METROPOLITAN AREA PLANNING
DEPARTMENT

Re: S/D 91-66 (Preliminary Plat) Conquest North Addition

CASE NUMBER: S/D 91-66 - CONQUEST NORTH ADDITION

FINAL PLAT

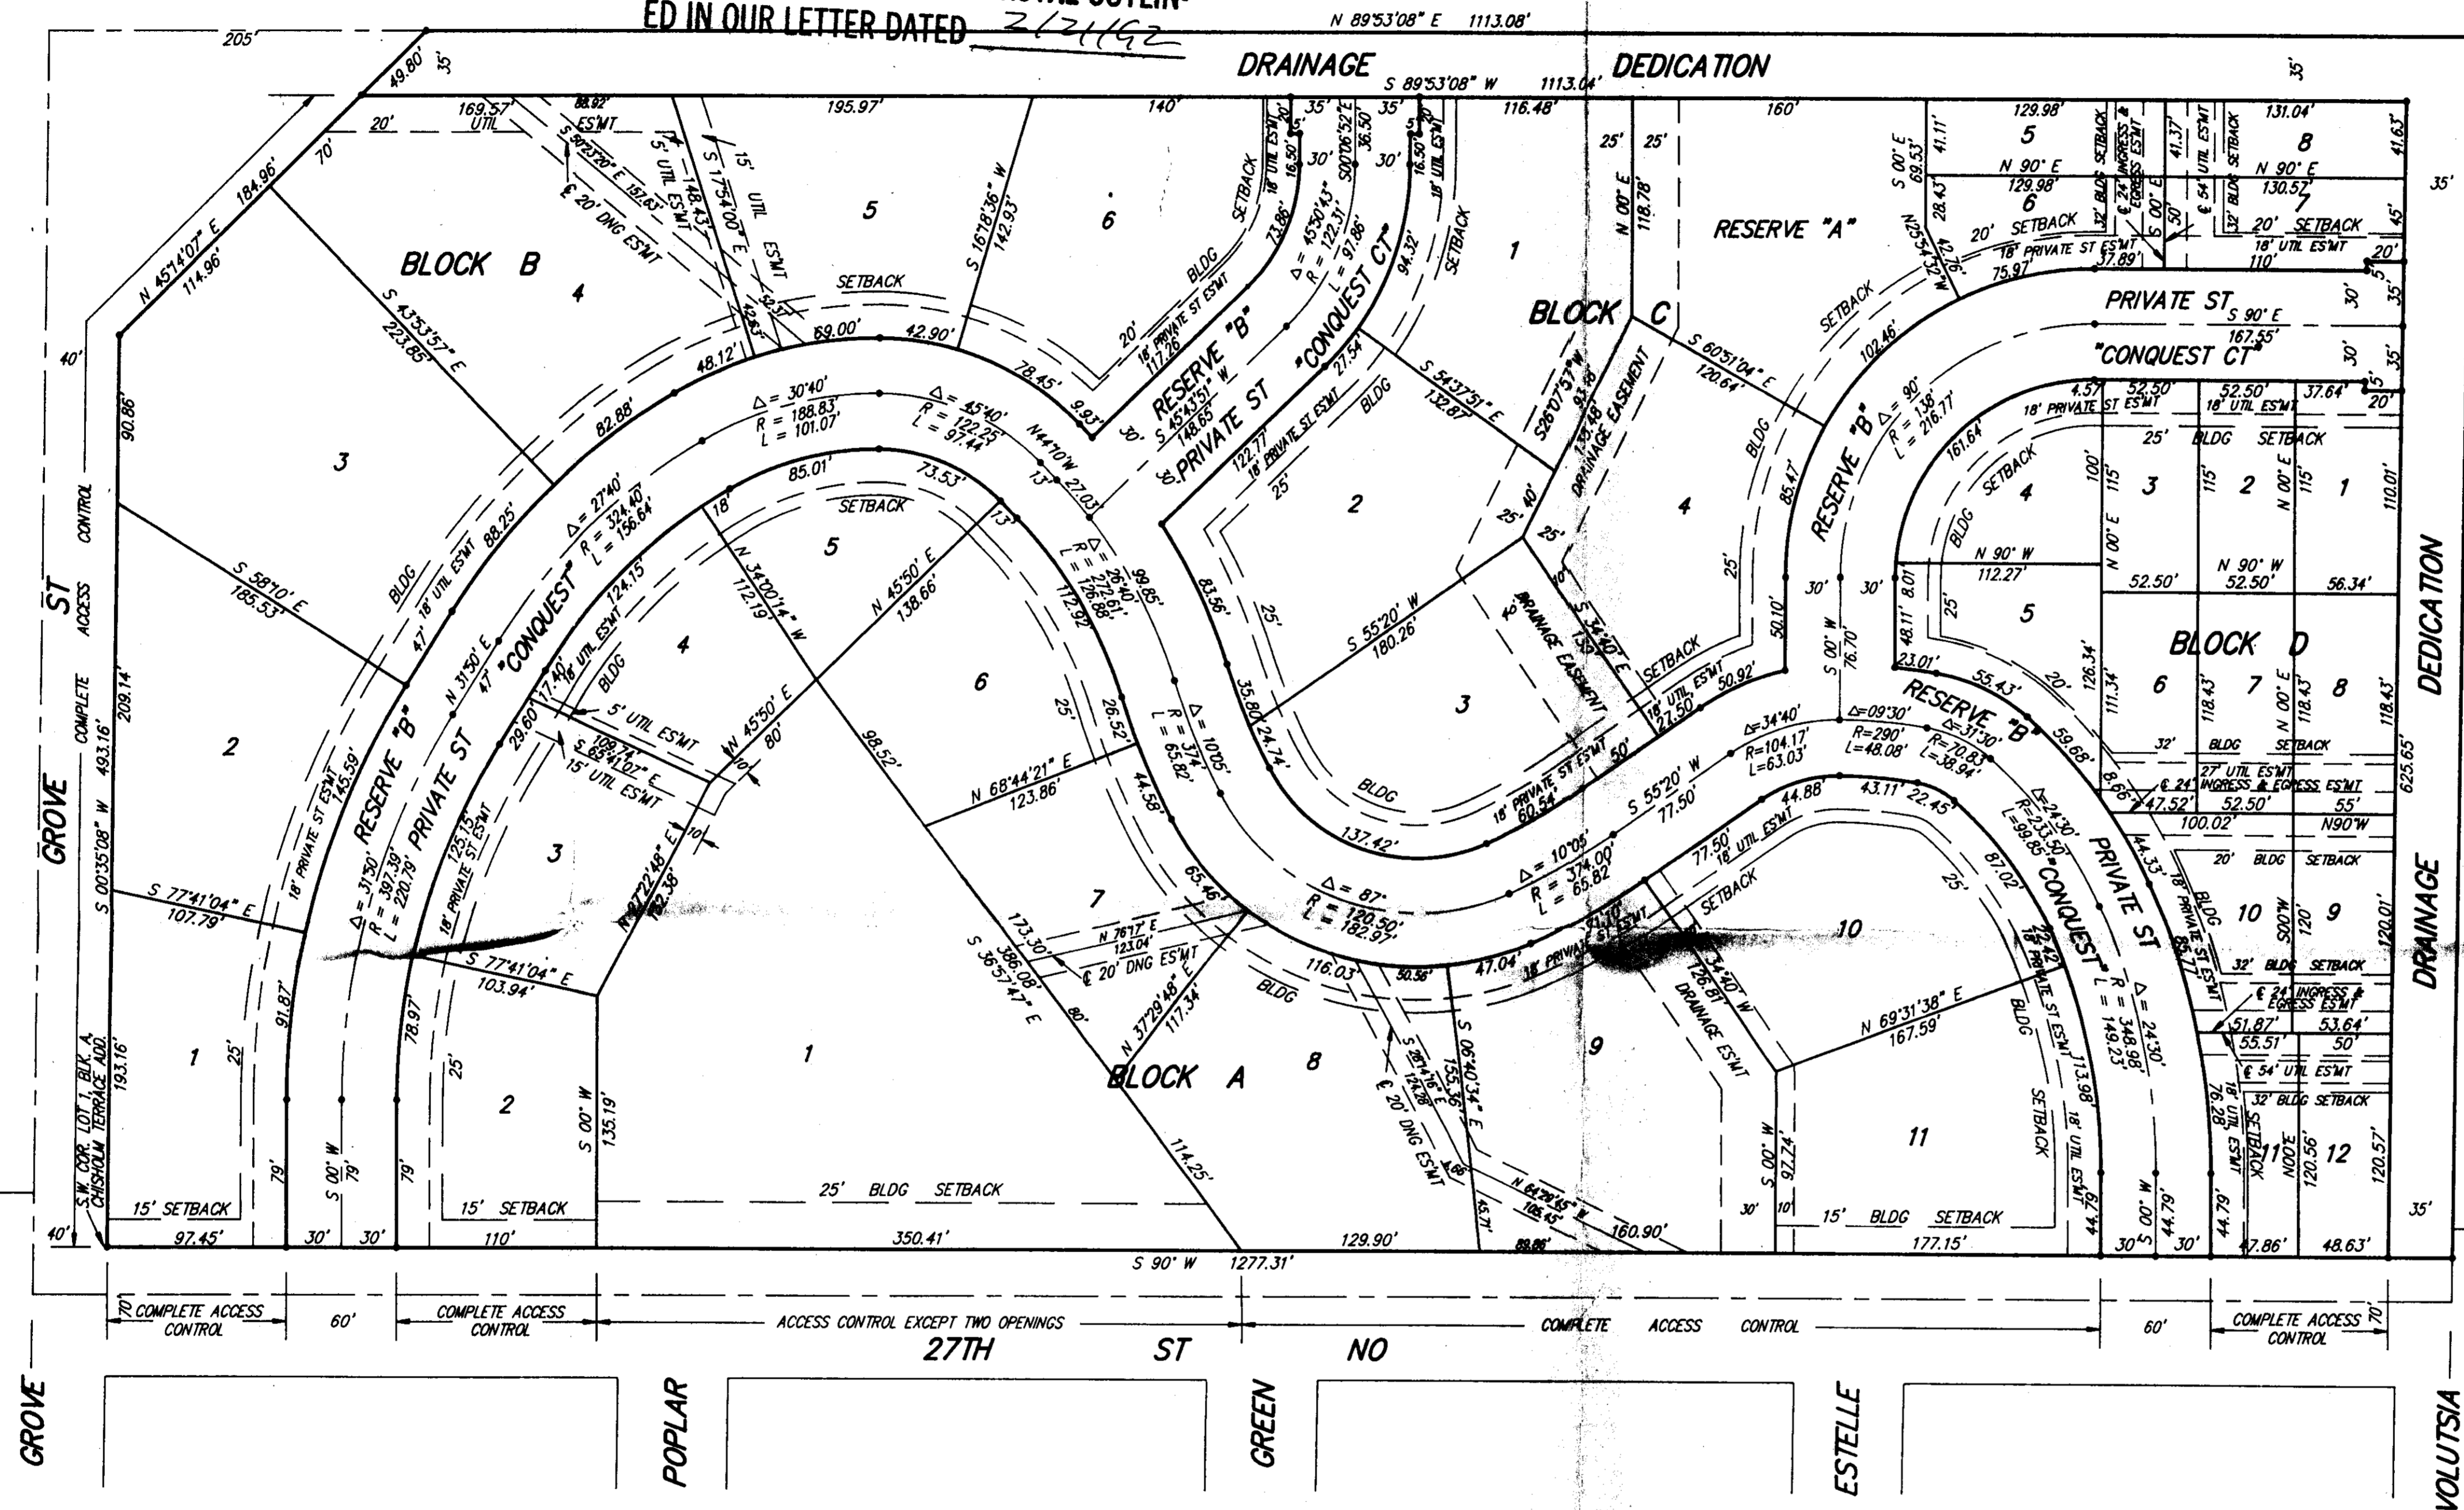
- L. Since lots 8 and 9, Block A involve double frontage with access intended from Conquest St., the final plat shall indicate complete access control across these lots' south lines to 27th St. North. Similarly, complete access control to Grove St. shall be indicated across the west line of lots 1, 2, and 3, Block B.

indicated on the plat. For the narrow lots in the eastern portion of this site, the platting of side yard setbacks seems to be an unnecessary restriction and may be deleted.

- R. On the final plat, in order to better locate the easements crossing lot 4, Block B and lots 8, and 9 Block A dimensions shall be shown from lot carriers to the easements.
